Missoula County has completed its review of the Draft Restoration Plan for the Clark Fork River and Blackfoot River near Milltown Dam. Written comments are enclosed with this letter, prepared by Mr. Dennis Gathard of G & G Associates and Peter Nielsen of Missoula County. Thank you for providing us with a copy of the draft report and the opportunity to submit comments.

Draft Restoration Plan for Restraining the Clark Fork River and Blackfoot River following the Removal of Milltown Dam

THE STATE OF MONTANA'S RESPONSES TO MISSOULA COUNTY COMMENTS ON THE *DRAFT RESTORATION PLAN FOR THE CLARK FORK RIVER AND BLACKFOOT RIVER NEAR MILLTOWN DAM* (April 2005)

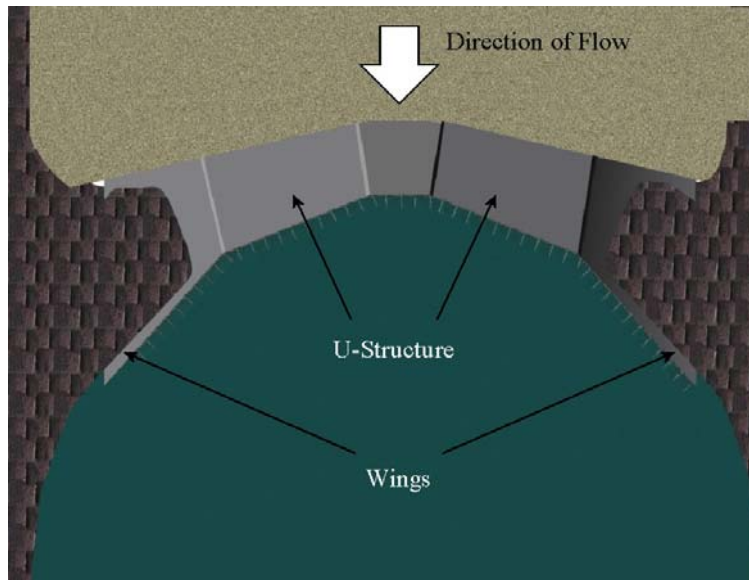
- The proposed profile at the downstream end of CFR3 is similar to the current thalweg elevation (approximately 3246 now versus approximately 3250 proposed). Treatment of CFR3 includes increasing sinuosity and removing mature vegetation. This would appear to create less stability rather more stability since, as discussed, mature vegetation provides a more stable river plan form than recent vegetation.
